City of Fayetteville, Arkansas

Planning Commission Final Agenda

Monday, September 22, 2025

1 TOWER ELEVATION
SCALE N.T.S.

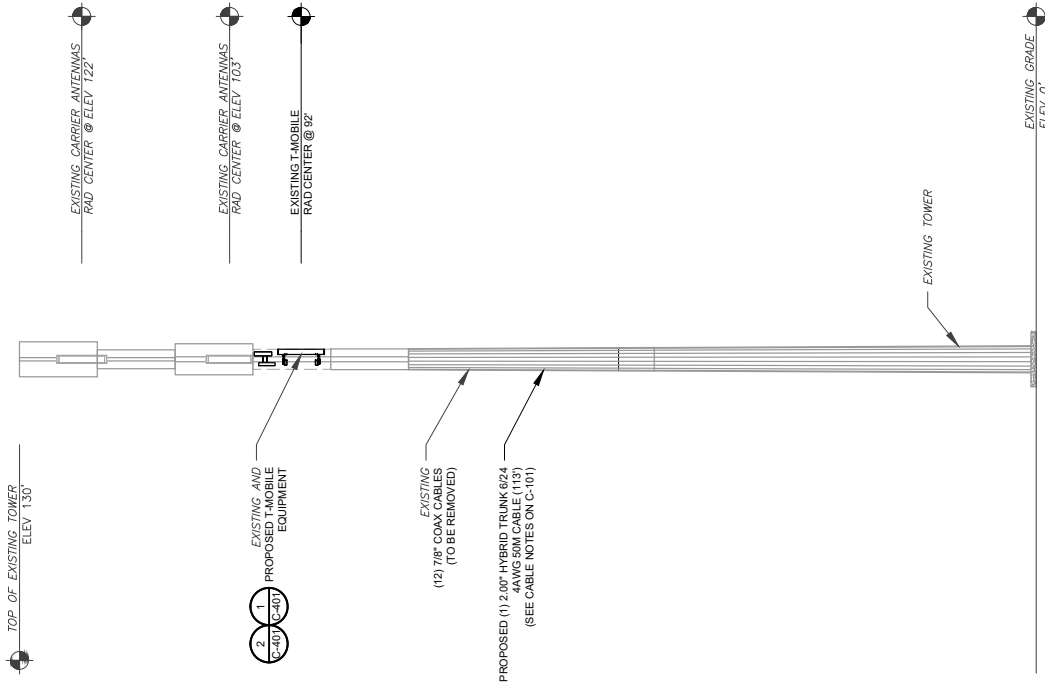
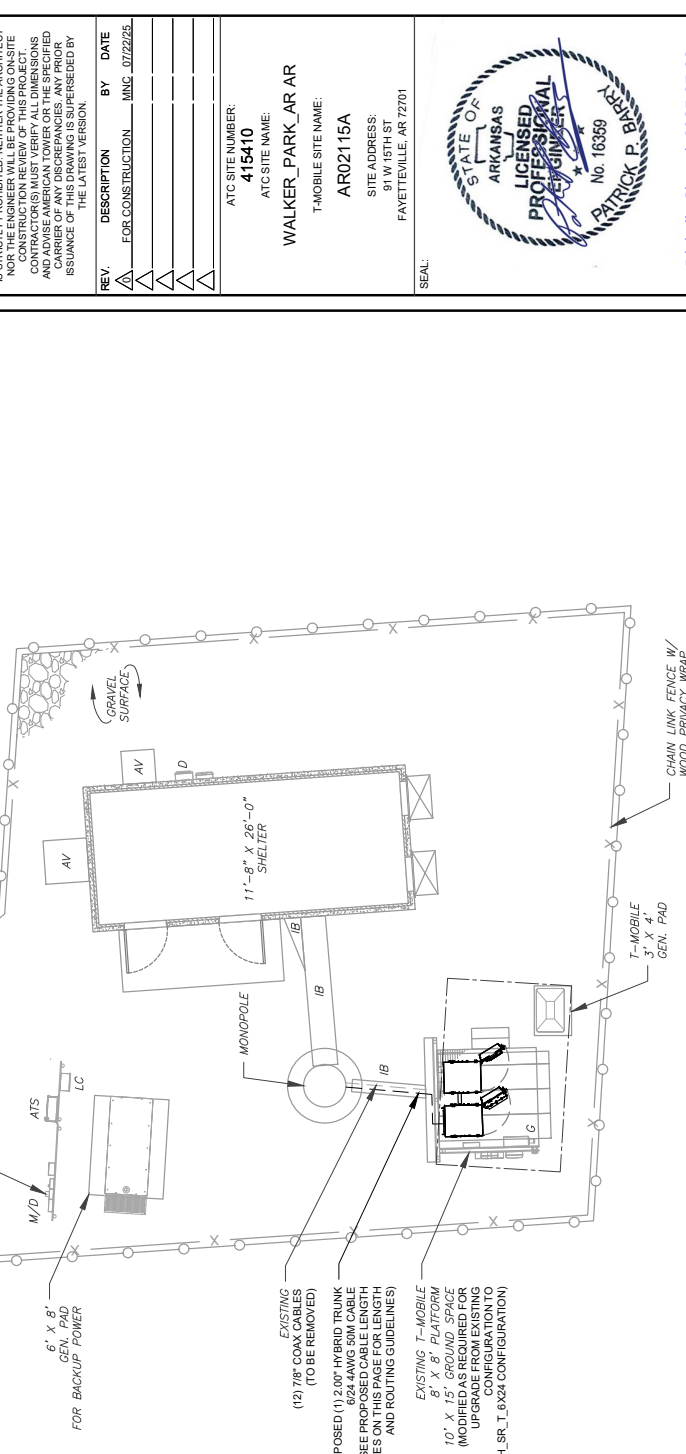
Staff support the applicants' modification with conditions. Ensuring that technology in existing cell towers remains up to date is critical for wireless communication transmission. The applicant is swapping out existing antennas for new ones. However, with that swap, the applicant will be replacing those antennas with slightly larger equipment and intends to remove the existing shroud to accommodate that. To maintain consistency and compatibility with the surrounding area, staff recommend that the tower remains shrouded and painted in the existing paint scheme, even if the canister will be slightly larger in some places than before.

1. The new antennas shall be shrouded and placed within a canister to be painted to match the existing tower color scheme.
2. All other conditions of the associated conditional use permit (CUP 07-2688) not affected by this modification shall remain in effect, as attached.

1 EXISTING GROUND EQUIPMENT LAYOUT

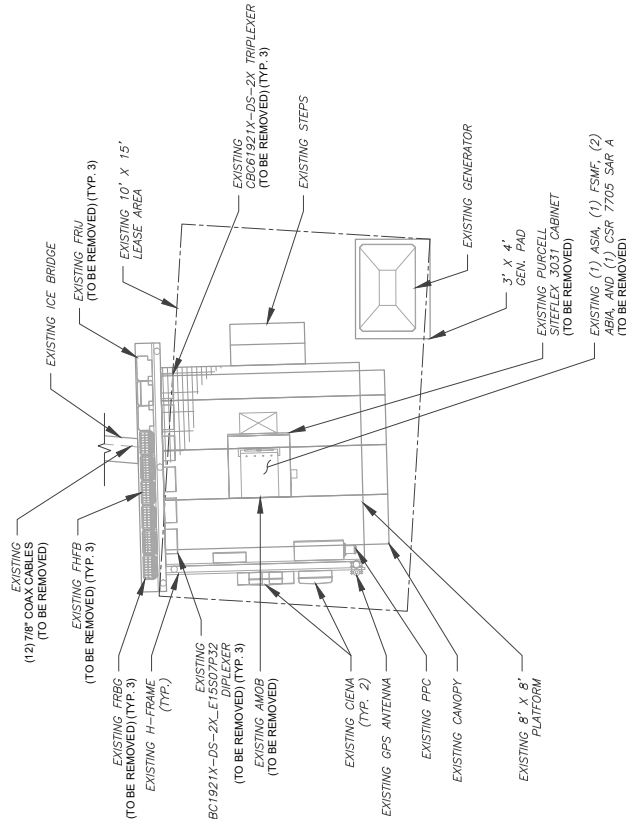
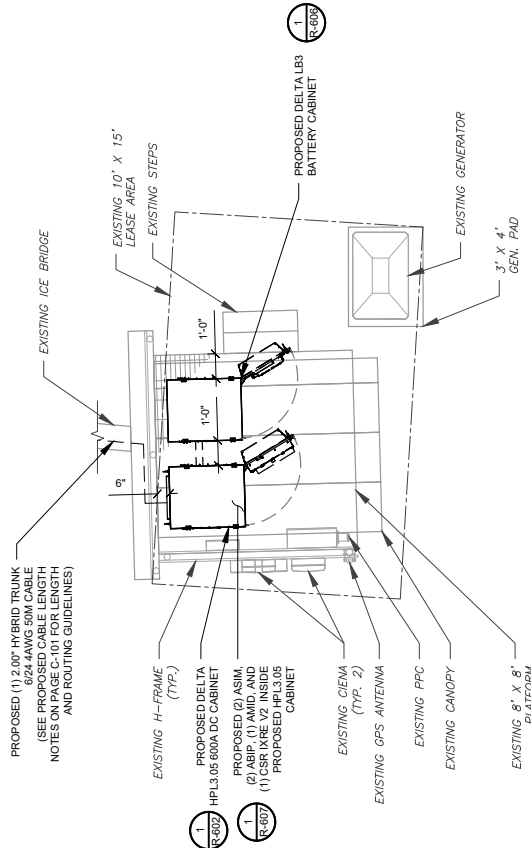
1. CONTRACTOR TO VERIFY THERE IS NO LIVE ANY FIBER RUNNING THROUGH EXISTING DEAD EQUIPMENT. IF SO, THIS WILL NEED TO BE RERUN THROUGH CONDUIT PRIOR TO REMOVING DEAD 25 (6201 CABS) EQUIPMENT.
2. ALL OPEN PORTS NEED TO BE SEALED / WEATHERPROOFED PROPERLY
3. ALL UNNEEDED / EXCESS EQUIPMENT AND GARBAGE TO BE REMOVED FROM EQUIPMENT AREA, DISPOSE OF MATERIALS PROPERLY OFF SITE.

SITE CONCEPT DRAWING, JOHNSON STORE
18 November, 2024 Scale: 1" = 20'

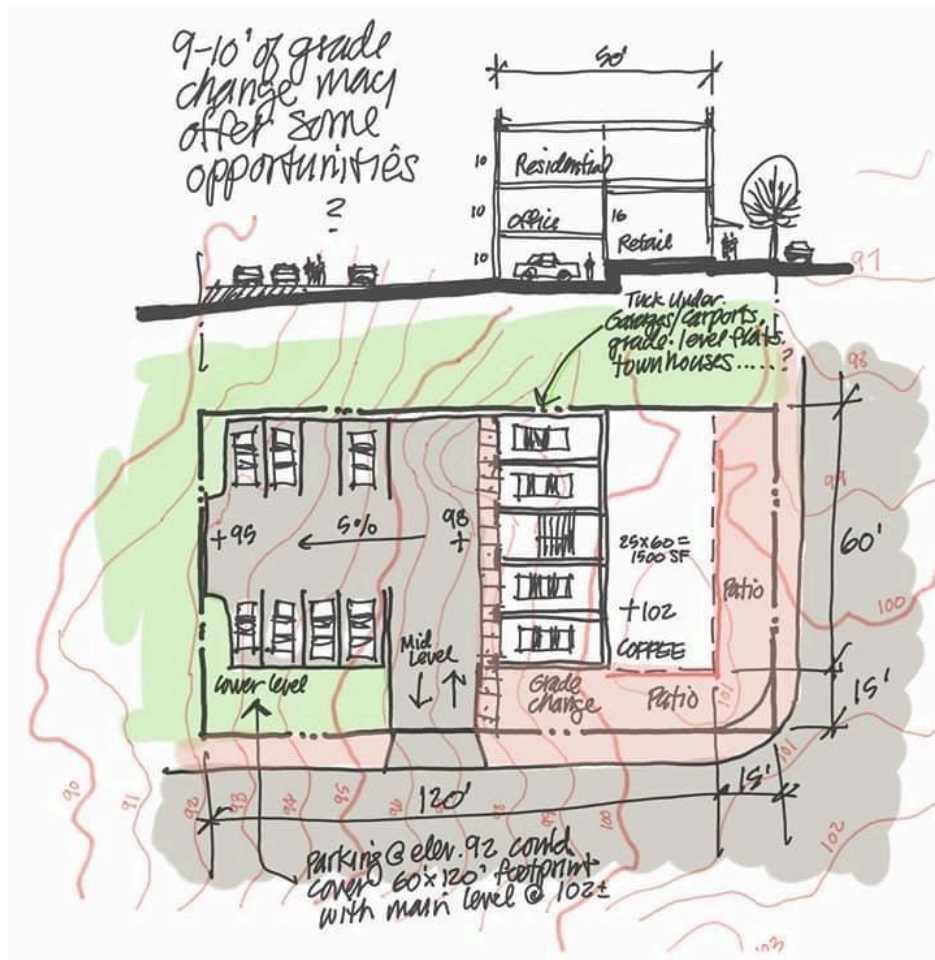
Engineering staff does not support the variance request to the curb cut separation at the proposed site. The applicant's site plan provides 83' of separation, which fails to meet the 100' requirement specified in the code (§166.08(F)) for Neighborhood Links. It is staff's opinion that granting this variance could reduce public safety at a relatively high-volume intersection. Staff's review of this matter included consideration of the following:

- Traffic Volume: The intersection of MLK Blvd. and S. College Ave. is a relatively high-volume intersection (13,000 and 4,200 vehicles per day, respectively) and these volumes will likely increase in the future as more development occurs in the southeast part of town.
- Turn Lanes: To accommodate traffic growth, the city has long-term plans to install left turn lanes at this intersection, which would be impacted by a non-compliant curb cut.
- Intersection Offset: The 12' north/south horizontal shift of MLK Blvd. as it crosses S. College Ave. requires drivers to adjust their lane position. Maximizing the distance between the driveway and the intersection would provide additional reaction time for drivers, enhancing safety.

Finally, if the Planning Commission decides to grant the variance for the full development, staff recommends requiring the driveway to be right-in/right-out only. The applicant has previously offered this as an option, and staff agrees it would help mitigate the safety risks associated with a non-compliant separation distance.
